Re: Application No.: 18-0219  
Applicant: ARYA Properties, LLC  
Block 21, Lots 621, 622 and 1712  
Manchester Township, Ocean County, New Jersey  
MC Project No. MCP-037

We received a copy of the above-referenced application for preliminary and final major subdivision approval. The subject of the application is the subdivision of three (3) existing lots to create 14 residential lots, a stormwater management lot and a commercial lot. The property has frontages along Ridgeway Avenue (County Route 571), Brentwood Avenue and Wilbur Avenue, and is within the B-1 Business/R-20 Overlay Zone.

#### **6. Subdivision Plat**

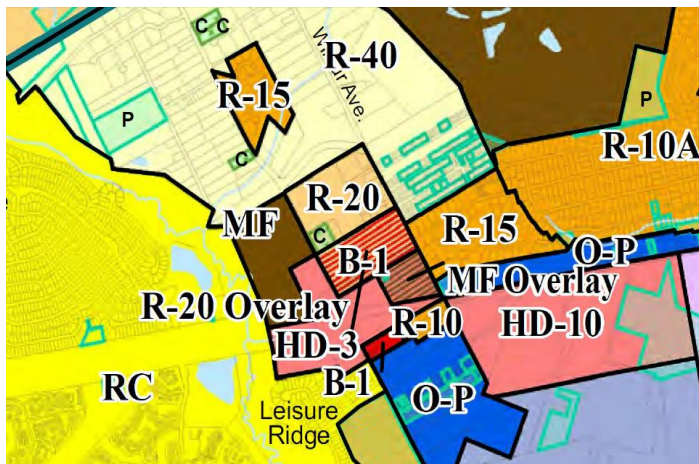
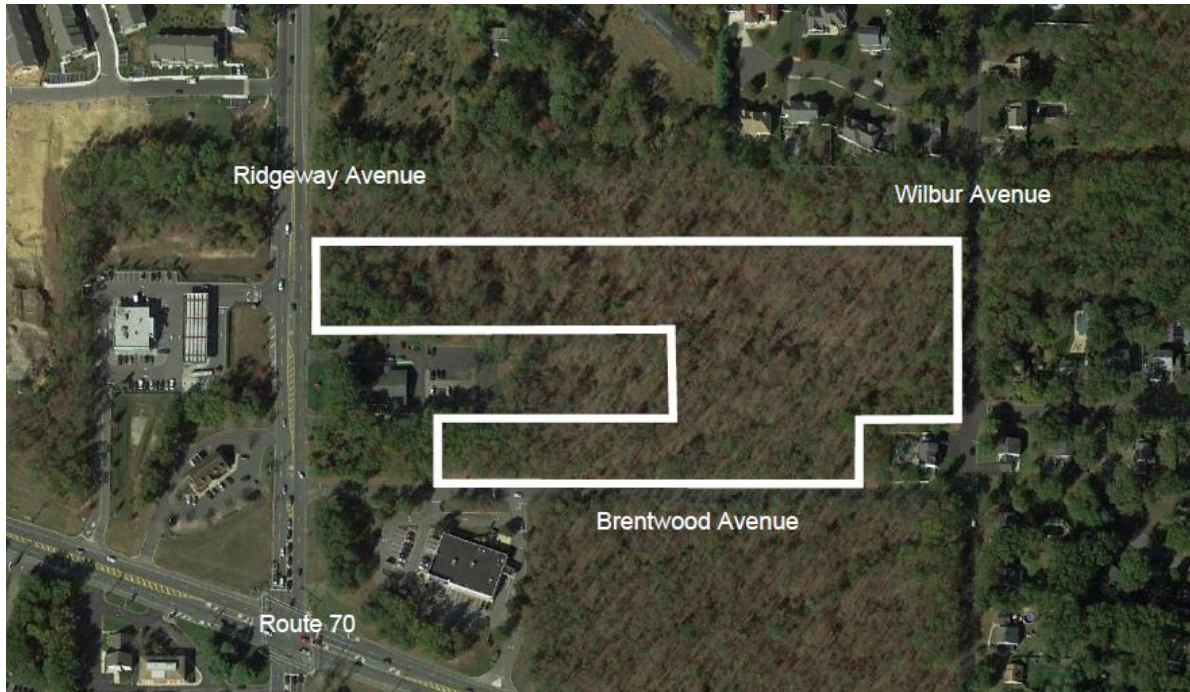
- 6.1. Block and lot numbers are subject to review and approval by the Township Tax Assessor. The street name is also subject to Township review and approval.
- 6.2. Lot numbers for the commercial and stormwater basin lots should be added to the plat.

- 6.3. There is a 20-foot wide access easement through the commercial lot to the basin lot. The applicable easement agreement should be provided for review.
- 6.4. We recommend monuments be set before the plat is submitted for filing.
